Council Ref: RAL/2024/3831

RE: RESPONSE TO FURTHER INFORMATION REQUEST – DEVELOPMENT PERMIT FOR RECONFIGURING A LOT– ONE (1) LOT INTO 35 LOTS IN STAGES AND ONE RESERVE - 2-26 BURNETT STREET, DARLING HEIGHTS - LOT 3 ON RP17828

Further to Council's Further Information Request dated 23 July 2024 for the above-mentioned application, Vision Surveys (QLD) Pty Ltd [VSQ] acts on behalf of Port Hacking 2229 Pty Ltd (the applicant) in submitting this response.

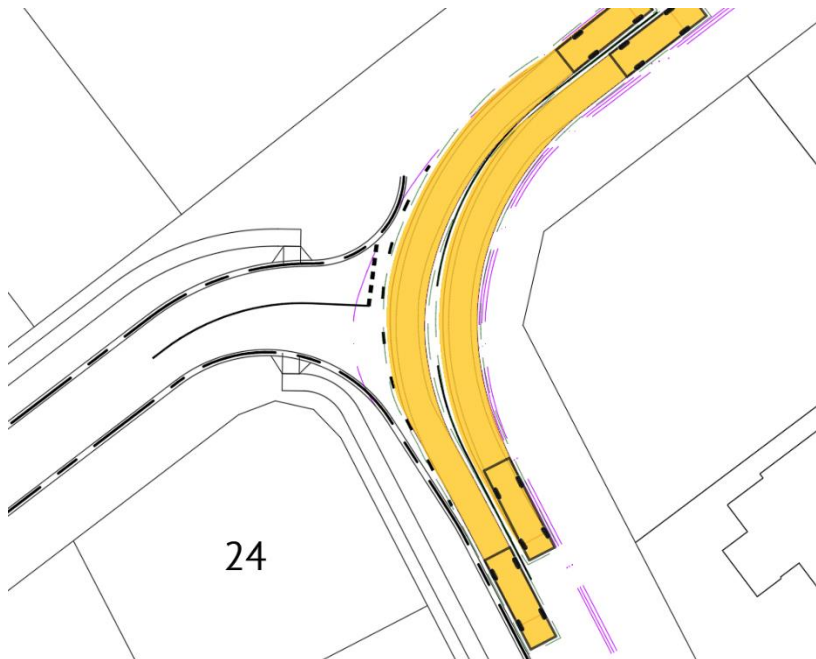
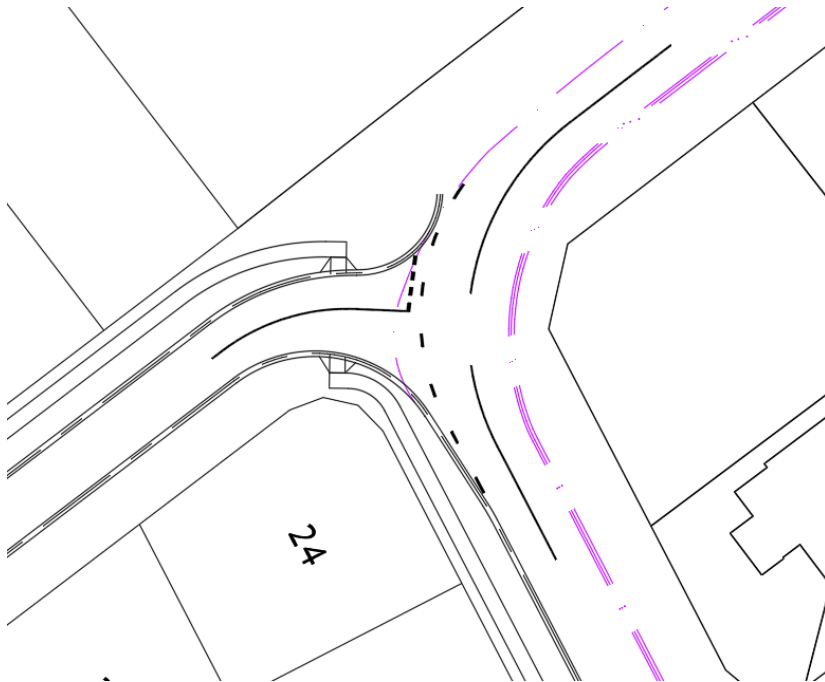
1.2 *The road access to Burnett Street associated with Stage 1 appears to form a through road with Rosenstengel Street. Given this is a cul-de-sac servicing 12 lots, it should terminate at a T intersection with Rosenstengel Street and Burnett Street forming the through road. There is no concept plan provided for this intersection. Further it is unclear whether proposed Lot 24 has sufficient truncation to allow the T-intersection to be formed this way.*

- *A conceptual intersection layout for the Stage 1 T-intersection with Burnett Street and Rosenstengel Street, with the Stage 1 street being the minor leg; and*
- *Amended plans which demonstrate that proposed Lot 24 has sufficient corner truncation to accommodate the intersection layout.*

Refer to response and plan by Premise for intersection details.

In addition, it is submitted that lot 24 has sufficient corner truncation to accommodate the intersection. There's a minimum of 4.0m of verge at the corner of lot 24 Refer details from Premise below.
